1R - 425-36

**From:** Katie Lee [katie@rthicksconsult.com]  
**Sent:** Monday, February 21, 2011 5:22 PM  
**To:** Hansen, Edward J., EMNRD  
**Cc:** 'Katie Jones'; Hack Conder; 'David Hamilton'  
**Subject:** CAP Addendum, Vacuum C-33, 1R425-36  
**Attachments:** C33CAPAddendumPlate7.pdf

This email is an Addendum to the Vacuum C-33 Site (1R425-36) Corrective Action Plan, submitted to the NMOCD on January 6, 2011. Page 6, section: Recommendation, paragraph 3: text in blue lettering, below, will be added to the paragraph. Red lettering marked with a strike-through will be deleted. The new Plate 7 showing the proposed liner location and re-vegetated areas is attached. If you need any further information, please let me or Hack and Katie at ROC know.

RE: NMOCD Case #: 1R425-36  
Vacuum C-33, T17S, R35E, Section 33  
Corrective Action Plan

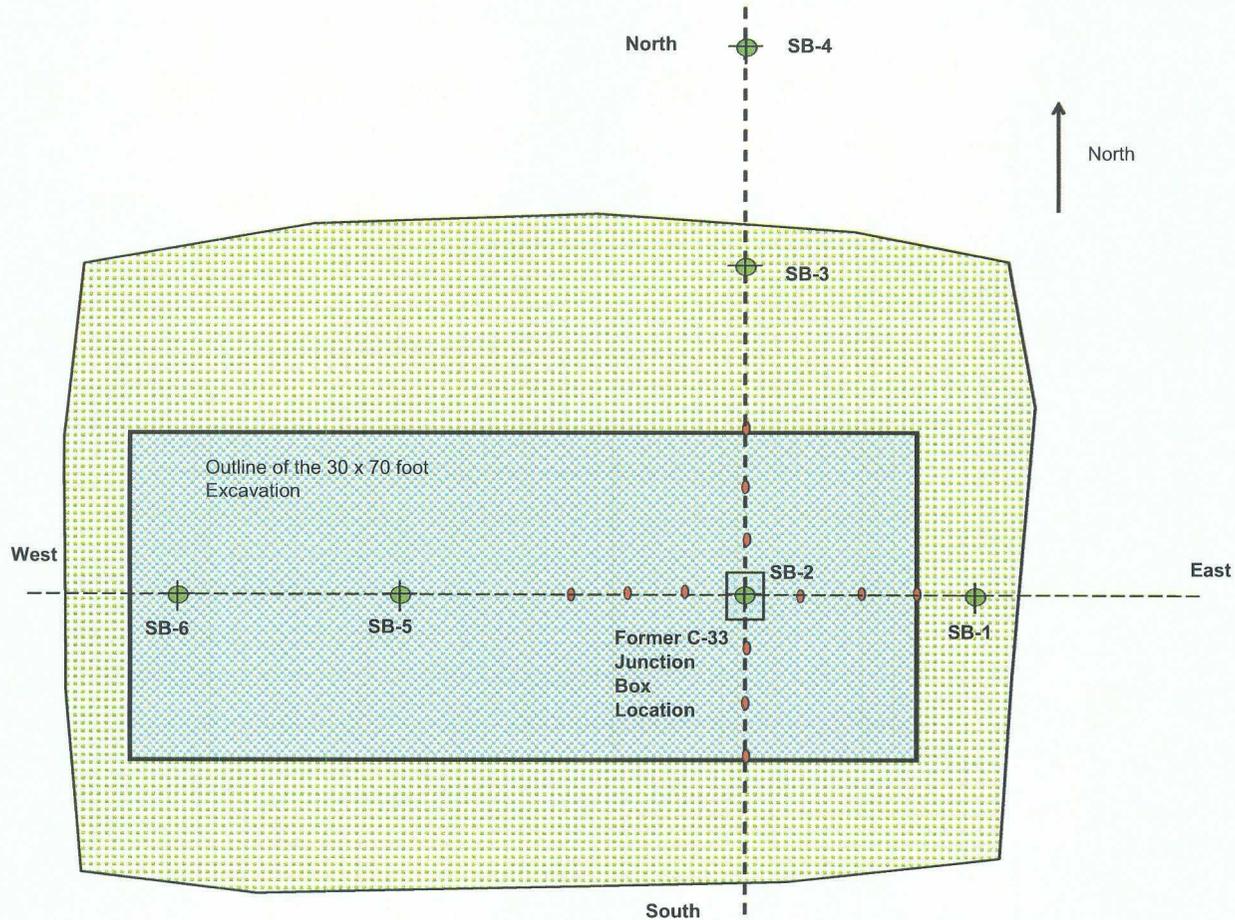
Our recommended corrective action ~~remedy~~ for the site is the installation of a 2,100 square foot synthetic liner 4 to 5-feet below ground surface over the former site, placement of soil over the liner and re-vegetation of the ground surface. This proposed remedy will limit infiltration of precipitation and the subsequent migration of constituents of concern to ground water. As part of this effort ROC plans to: ~~includes the following work:~~

- Excavate the 30-foot by 70 ~~30-foot~~ area (shown on Plates 6 and 7) to a depth of four to five-feet; and place a liner at the bottom. ~~Clean fill with a chloride concentration below 500 mg/kg and a PID (field) reading below 100 ppm will be imported to replace excavated material.~~

- Fill material for the excavation will have a chloride concentration of less than 500 mg/kg and a PID (field) reading of less than 100 ppm. The excavated soil will be evaluated and used provided it meets these criteria. Any soils requiring disposal will be properly disposed of at an NMOCD approved facility.

- Upon completion of the liner installation, re-vegetate the disturbed ~~a 45-foot by 45-foot~~ area centered over the former excavation at the C-33 site to reduce infiltration (Plate 7).
